City Planning Commission
Sacramento, California

- Subject: 1. Special Permit Modification to construct an interim surface parking lot (P86-409)
2. Variance to allow 49 tandem valet parking spaces

Location: 3939 & 4001 J Street

Modified Site Plan

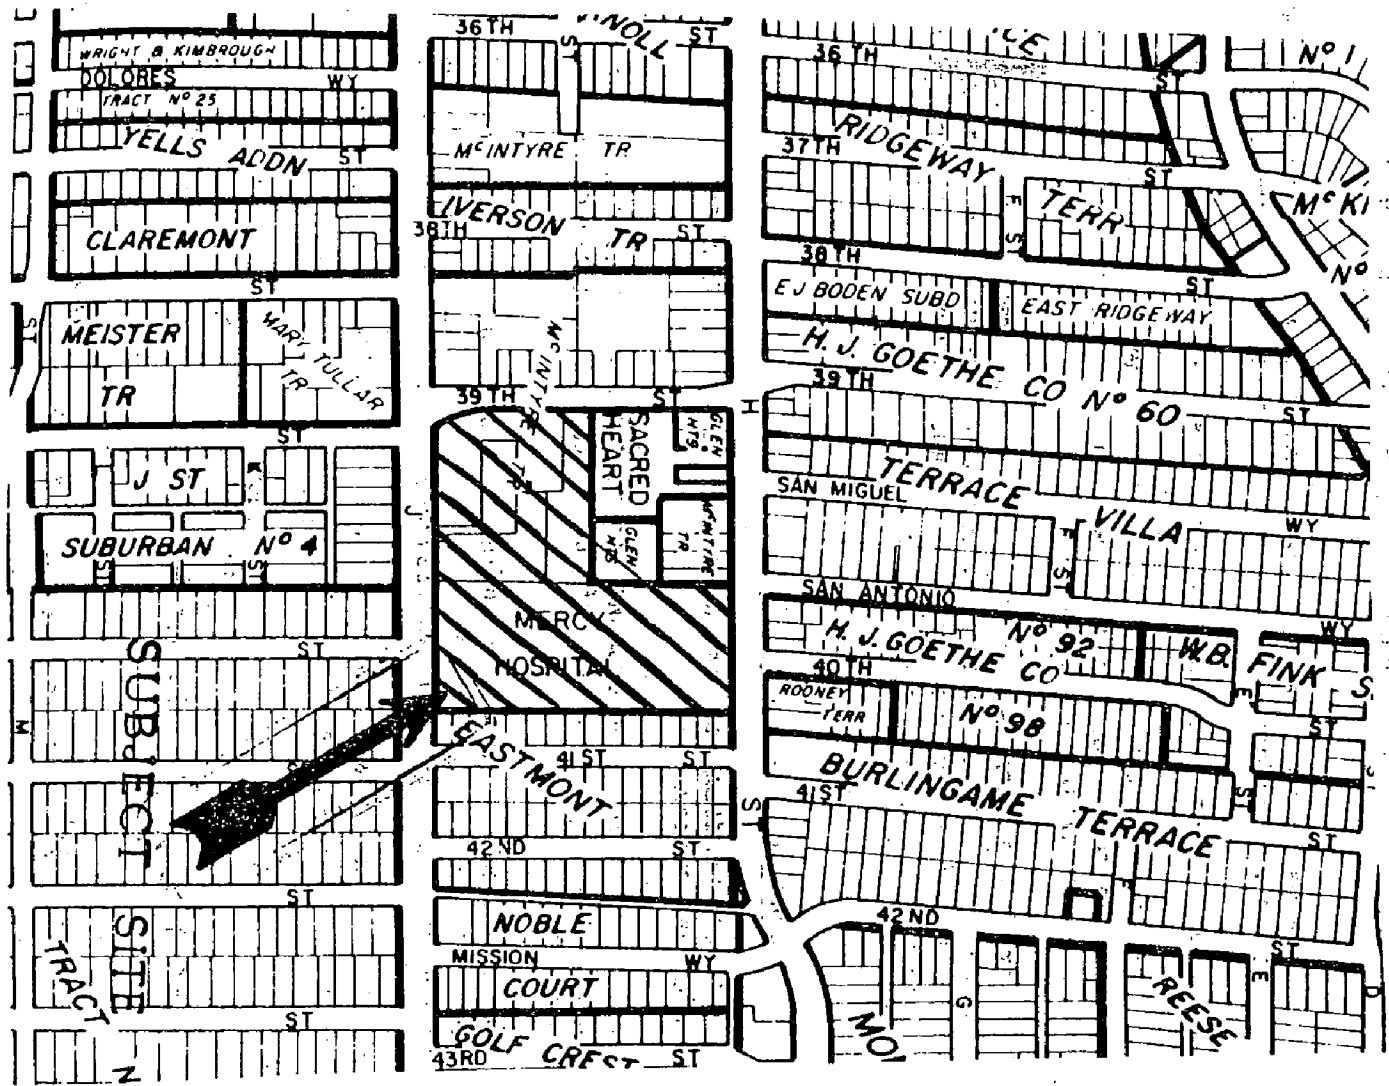
In addition, 49 tandem valet parking spaces will be provided in the interim lot (see modified site plan). The tandem spaces will have access limited to doctors only and an attendant will be provided to move and park cars.

- "1. That all of the conditions previously required by the Planning Commission for Mercy's initial parking structure (P86-409; approved 12/18/86) be required for this proposal; and
- "2. That the 25' bermed landscaping fronting J Street be extended to the 41st Street end of Mercy's property.

"In addition, one of the conditions previously required by the Commission in their 1986 approval was not readily apparent on Mercy's current plans. Specifically this is the requirement that the landscaping in the 25' setback zone be bermed with appropriate plantings to insure that no car can be seen from the street. This is particularly important to the neighborhood."

- A. Approve the special permit modification subject to the original conditions of approval and findings of fact in the attached staff report and the addition of the following condition:
 1. The construction on the permanent east parking structure shall commence no later than 1-1/2 years from the date of approval of this modification (August 13, 1989).

2. A detail landscape/irrigation plan for the temporary lot shall be submitted to the Planning Director for review and approval prior to issuance of building permits.
3. *Mature trees (minimum 15-gallon) shall be planted along J Street. The number and location shall be subject to Planning Director review and approval.
(CPC added)*

1. The 49 tandem spaces shall be used by medical staff only.
2. The tandem spaces shall be identified with signs indicating that the spaces are tandem and are for medical staff only.
3. A parking attendant shall be provided to assist persons using the lot and to keep the general public from the lot.
